Ginna Station

UFSAR Section 6.2.4 and Tables 6.2-13, 6.2-14 and 6.2-15 Changes

NSL-0000-SA024

Revision 3

Figure 6.2-13
 S/G Inspection/Maintenance,
~~Penetration No. 29~~
 Fuel Transfer Tube, Penetration No. 29

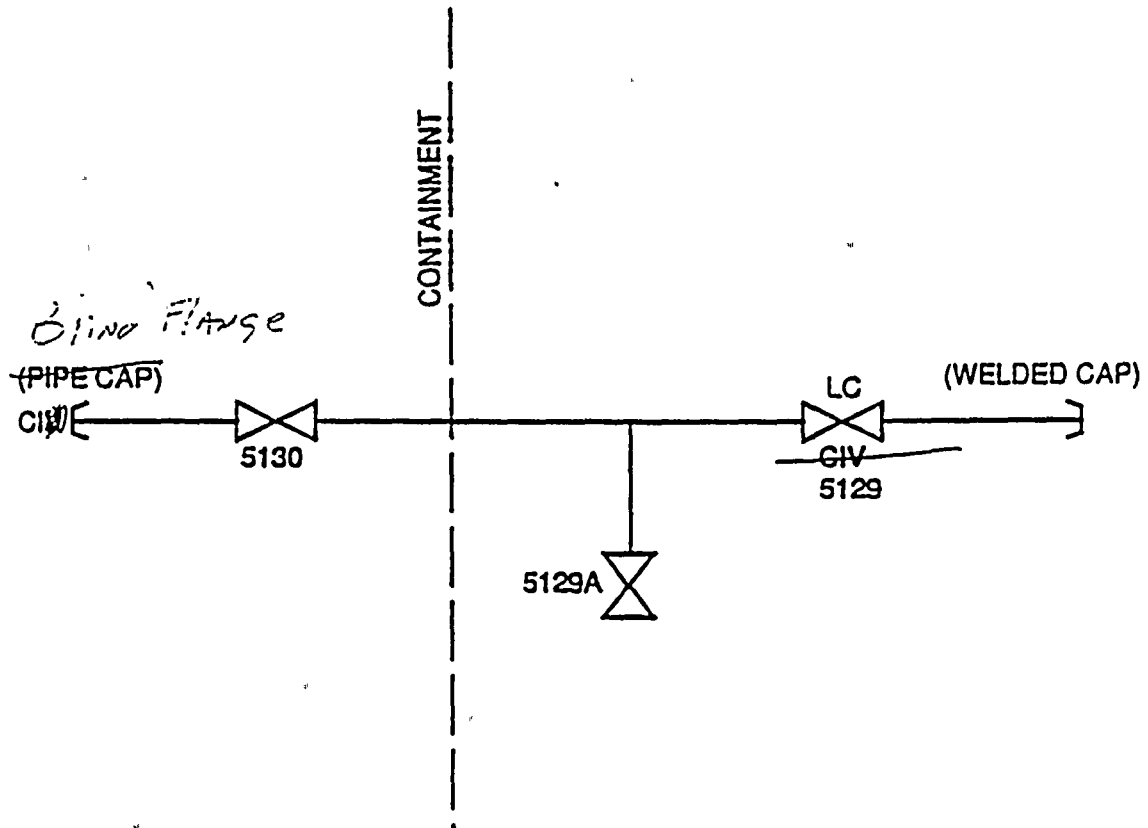
- (1) Penetration number 2 was added as a result of EWR 4998 to facilitate steam generator maintenance activities during reduced inventory operation. This penetration is closed by a double-gasketed on both ends; however, only one of the two flanges is necessary for containment integrity purposes.

No.	Change	Effect
1.	Penetration 2 - Added penetration and necessary information to the table.	This spare penetration was modified to provide access for steam generator inspection and maintenance cabling during refueling outages to enhance containment closure during midloop operations. No new valves were added.

Figure 6.2-17
 Construction Fire Service Water
 Penetration No. 103

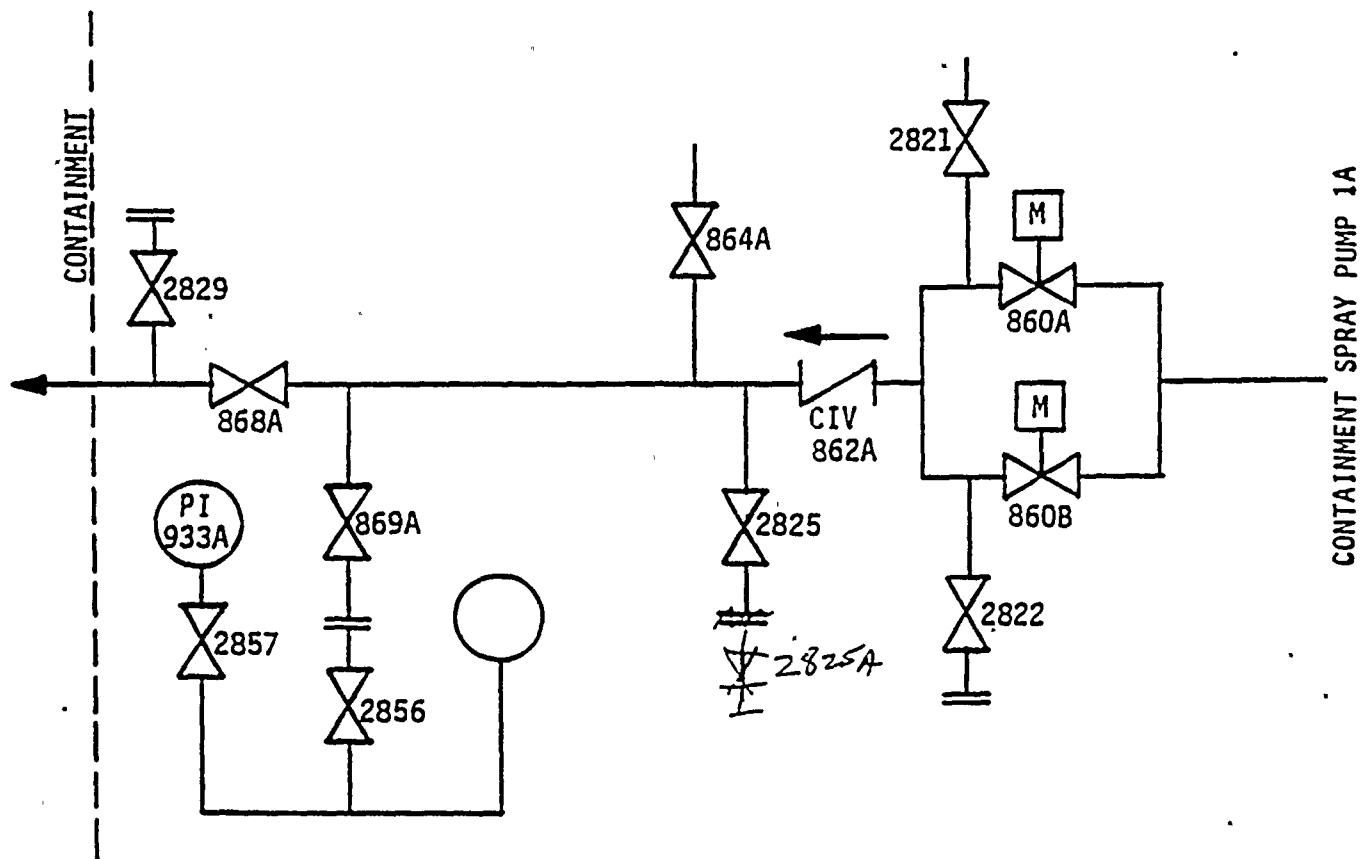
- (a) Penetration 103 - Valve 5129 was deleted from the table and replaced by a Blind Flange. This change enabled the elimination of the previous note of "No longer in use" that was associated with this penetration. The penetration now reflects the current configuration. The use of the Blind Flange is consistent with the previous locked-closed manual valve.

5.	Penetration 102 - (1) Global Notes 1, 2, 4, and 5; (2) Added Note 4.	(1) (2) No technical change.
6.	Penetration 103 - Deleted valve 5129 (entire line in table) and replaced with Blind Flange.	Replaced Note of "No longer in use" to reflect accurate configuration status of Blind Flange. The use of the Blind Flange is consistent with the previously listed locked-closed manual valve.

Residual Heat Removal to "B"
 Cold Leg, Penetration No. 111

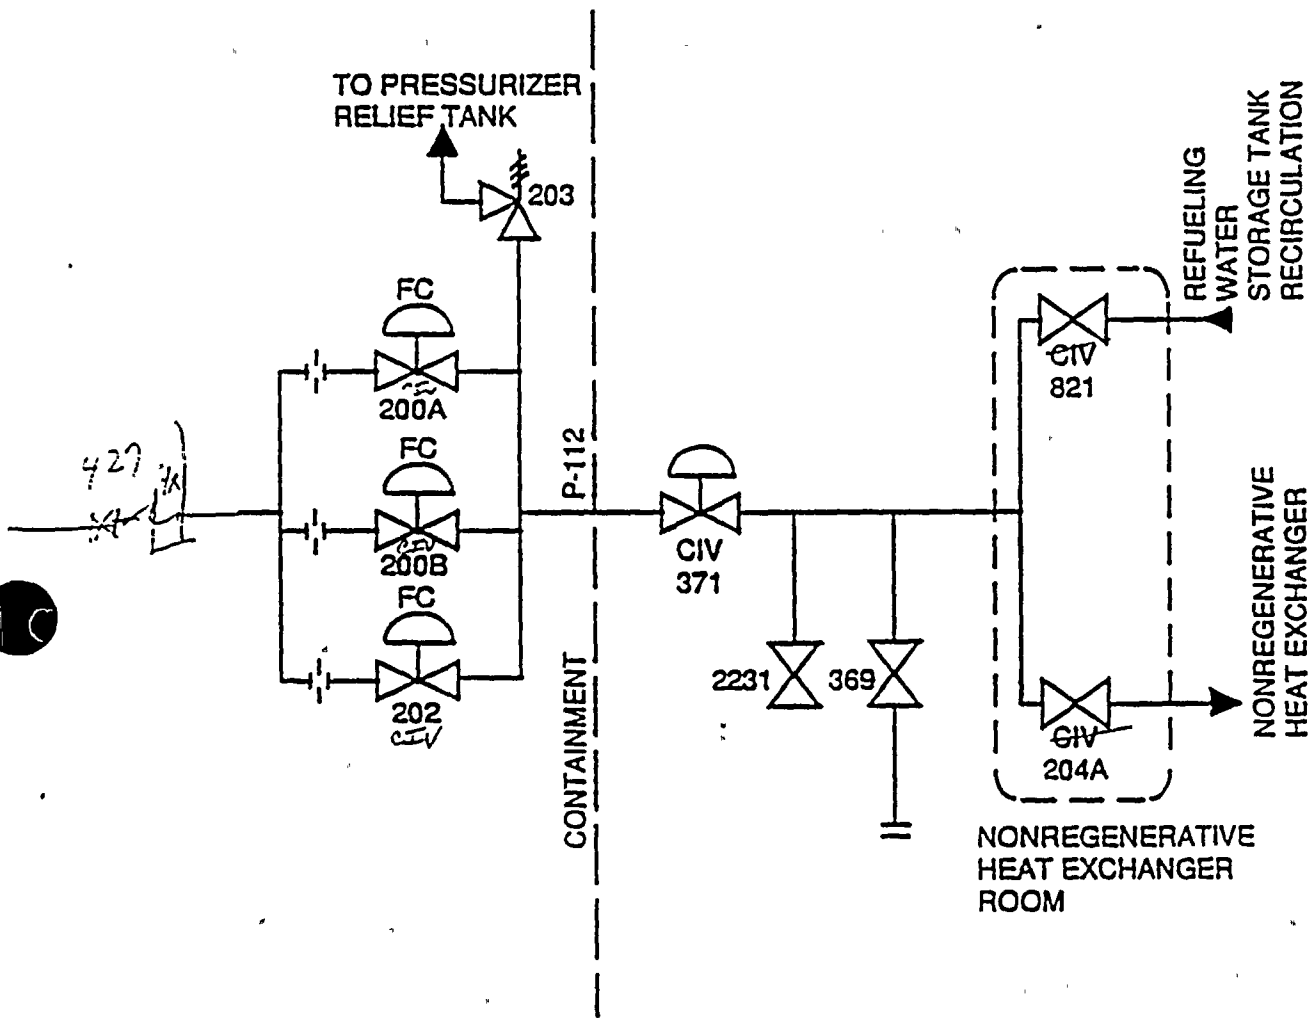
- (b) Penetration 111 - Added valve 959. The addition of this valve to the table ensures that all valves receiving a containment isolation signal are listed. This valve was previously missing from the table, but credit was not taken for the valve during the SEP (see Reference 2.7). Consequently, this is not considered an actual isolation valve and is not tested per Appendix J.

Section 6.2.4.4.4.2 - The discussion concerning line 111 was revised to show that only one motor-operated valve is provided for this penetration instead of the two previously listed. The basis for this change is the same as discussed in Section 3.4.1.

14.	Penetration 111 - (1) Added Note 7 to both valves; (2) Added Note 8 to valve 720; (3) Added Note 4 to both valves; (4) Changed <u>Position Indication In Control Room</u> from "Yes" to "R/G" for MOV 720; (5) Added valve 959 and necessary information.	(1) Consistency with Technical Specifications. (2) (3) No technical change. (4) Minor clarification only. No technical change. (5) Valve receives containment isolation signal and was previously missing from the table.

Figure 6.2-25
 Letdown to Nonregenerative Heat
 Exchanger, Penetration No. 112

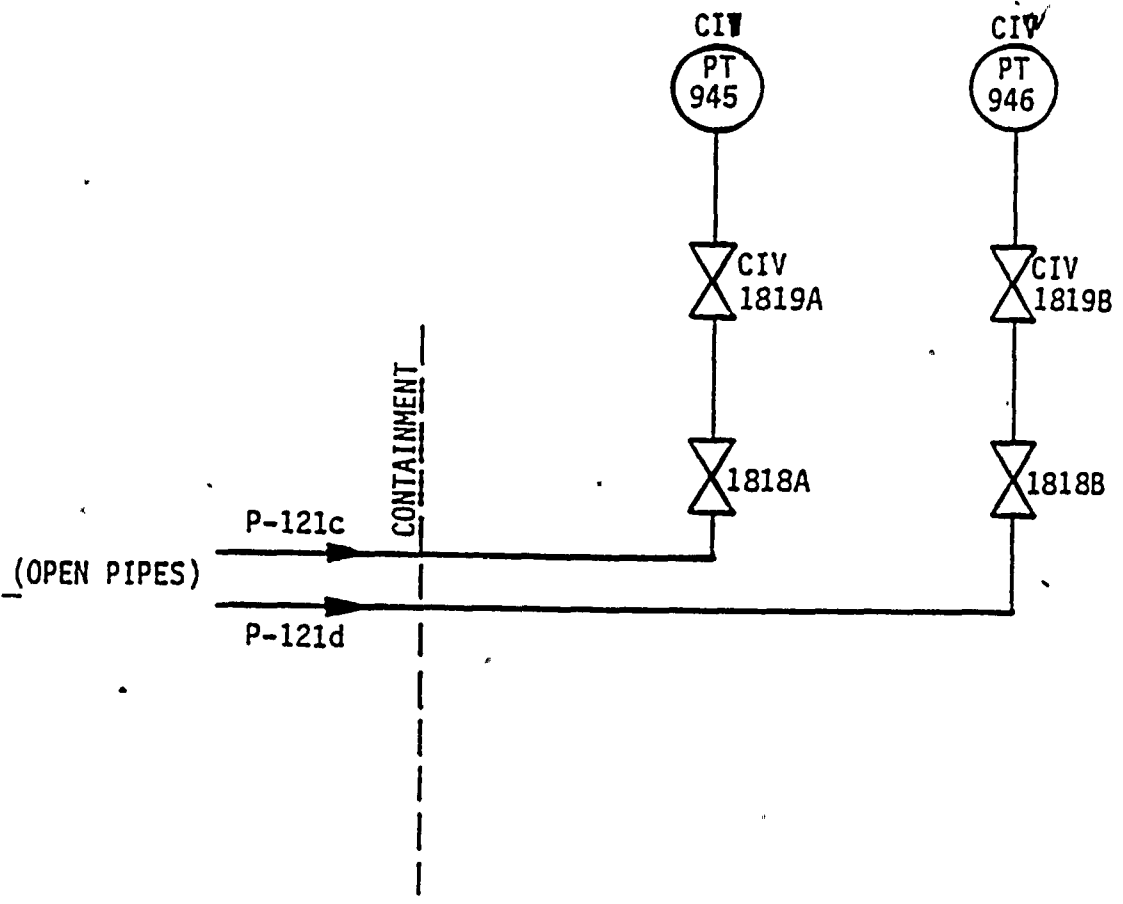
- (c) Penetration 112 - Valves 204A and 821 were deleted and replaced with valves 200A, 200B, and 202. Valve 427 was also added. The addition of these valves enables explicit compliance with GDC 55 versus the use of the two redundant isolation valves. These new valves are included in the current IST program (see Reference 2.19).

- (10) Containment isolation signals were added to AOVs 200A, 200B, and 202 since AOV 427 fails open on loss of power. The isolation signal for these three valves is relayed from AOV 427.

15.	Penetration 112 - (1) Deleted valves 204A and 821 (entire line in table) and replaced with valves 200A, 200B, and 202; (2) Added valve 427 and necessary information; (3) Changed <u>Position Indication In Control Room</u> from "Yes" to "Both" for valve 371; (4) Changed <u>Position At Immediate Postaccident</u> from "O" to "C" for valve 371.	(1) (2) Present configuration status; the three new valves enable explicit compliance with GDC 55 vs. the use of redundant outboard isolation valves. The 200A, 200B, 202, and 427 valves have been successfully tested. (3) Minor clarification only. No technical change. (4) Update for better representation of system configuration since letdown is isolated upon receipt of a SI signal.

Figure 6.2-31
 Containment Pressure Sensing
 Transmitters, Penetration Nos. 121c
 and 121d

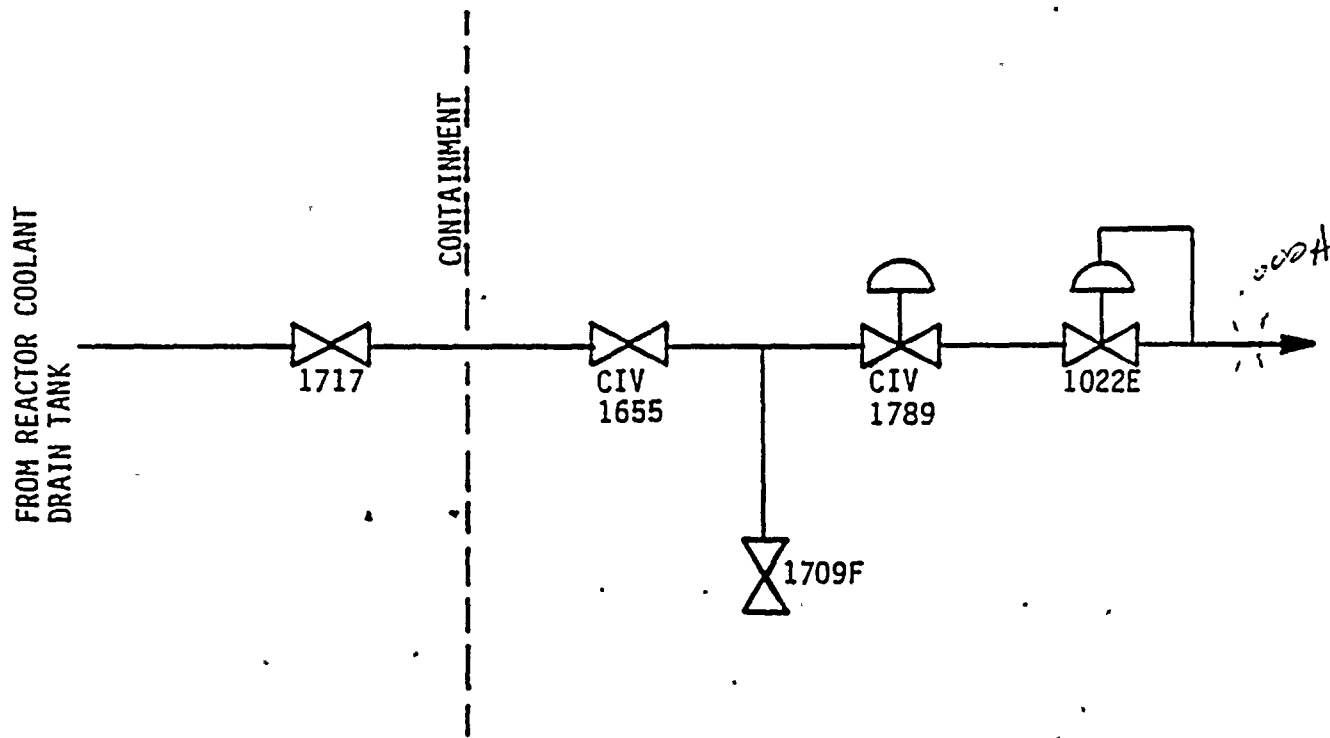
22.	Penetration 121c - (1) Global Note 1 for PT945; (2) Global Notes 3 and 4 for valve 1819A; (3) Added "Gate" under <u>Valve Type</u> for valve 1819A.	(1) (2) No technical change. (3) Correction of typographical omission. No technical change.

23.	Penetration 121d - (1) Global Note 1 for PT946; (2) Global Notes 3 and 4 for valve 1819B.	(1) (2) No technical change.
24.	Penetration 123 (bottom) - (1) Added "to" before "Gas Analyzer Line" under <u>System</u> ; (2) Global Notes 3 and 4 for 1655; (3) Changed valve 1789 from "Globe" to "Diaphragm"; (4) Changed <u>Position Indication In Control Room</u> from "Yes" to "Status" for valve 1789; (5) Changed <u>Position At Normal Operation</u> from "O/C" to "O" for valve 1789; (6) Added valve 1600A; (7) Reordered penetration valves.	(1) Consistency with Technical Specification Table 3.6-1. (2) No technical change. (3) Correction of typographical error. No technical change. (4) Minor clarification only. No technical change. (5) Update for better representation of system configuration since this line remains open. (6) Valve receives containment isolation signal and was previously missing from the table. (7) Valves now in numeric order. No technical change.

Figure 6.2-32

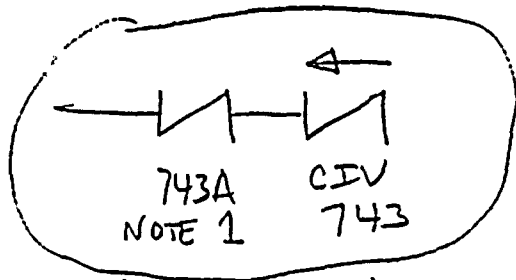
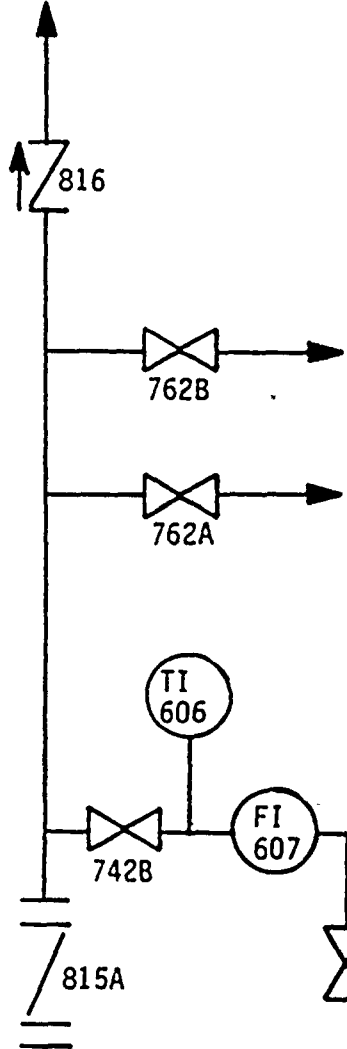
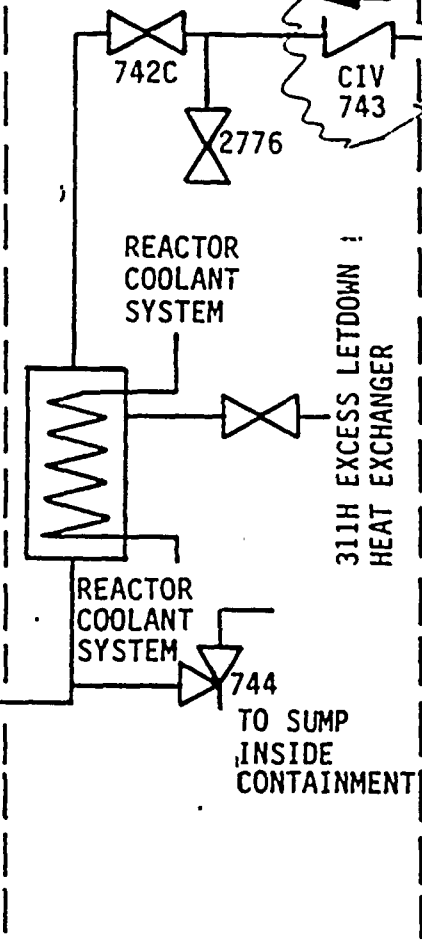
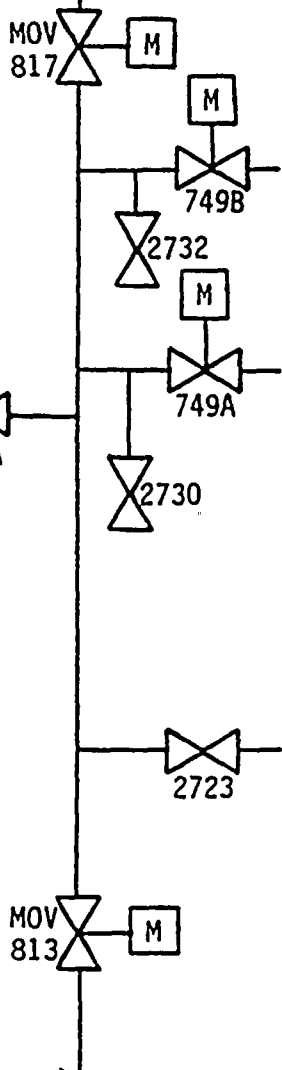
- (d) 123 (bottom) - Added valve 1600A. See explanation for 3.3.2.7 (b) above.
- (e) Penetration 141 - Deleted valve 851A and added valve 1813A. Valve 851A does not meet the selection criteria for 10CFR50 Appendix J, Section IIH, items 1 through 4. Consequently, the valve was deleted from the table. Valve 1813A was previously missing from the table. This valve is locked-closed with its breaker locked open.

make like this

ROCHESTER GAS AND ELECTRIC CORPORATION
 R. E. GINNA NUCLEAR POWER PLANT
 UPDATED FINAL SAFETY ANALYSIS REPORT
 Figure 6.2-37
 Component Cooling Water to Reactor
 Coolant Pump 1A, Penetration No. 127

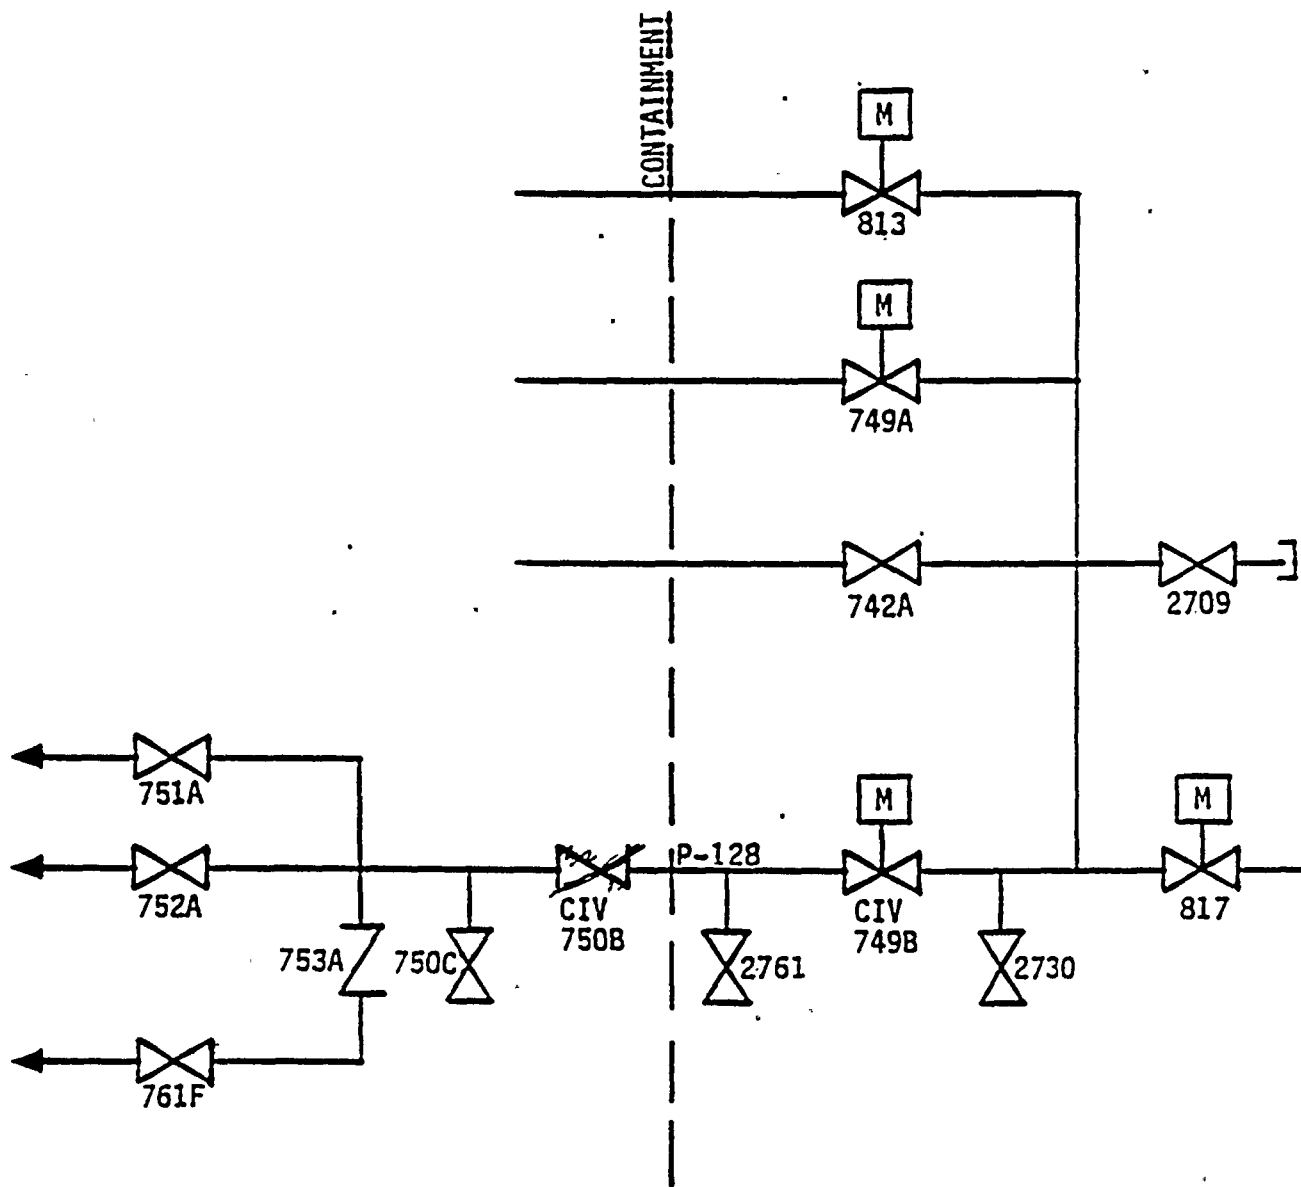
30.	Penetration 127 - (1) Changed <u>Position Indication In Control Room</u> from "Yes" to "R/B" for valve 749A; (2) Changed <u>Position At Cold Shutdown</u> from "O" to "C" for valve 749A; (3) Global Notes 1, 2, and 4 for valve 750A; (4) Changed <u>Maximum Isolation Time</u> from "60" to "NA" for valve 749A.	(1) Minor clarification only. No technical change. (2) Update for better representation of system configuration since RCPs are not operating during cold shutdown conditions. (3) No technical change. (4) Correction of typographical error. No technical change.
